RE: 2021 Unified Development Code & Comprehensive Plan Amendments

Canyon Highway District No. 4 (CHD4) has received notice of the proposed Star Unified Development Code and Comprehensive Plan Amendments. Staff has reviewed the application and associated draft materials available for the December 21, 2021 Council meeting, and offers the following comments on these matters:

STANDARD DRAWING No. ACCHD-107B
 CANYON COUNTY HIGHWAY DISTRICTS
 CANYON COUNTY, IDAHO

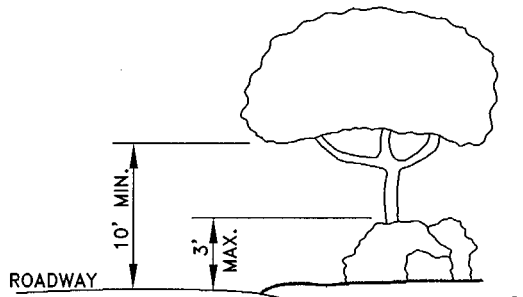
6. **Section 8-8A-6.A.2 General Sign Requirements- Vision Triangle:** Please see the attached minimum standards for intersection sight distance recommended by AASHTO (ACCHD SD-107B). Signs should not be located within this recommended vision triangle to provide for safe operation of public streets and driveway approaches.

Obstructions between 3' and 10' above the roadway centerline surface elevation are prohibited within sight triangles

Sight triangles for controlled intersections shall also meet the Idaho Code requirements shown on Standard Drawing No. ACCHD-107
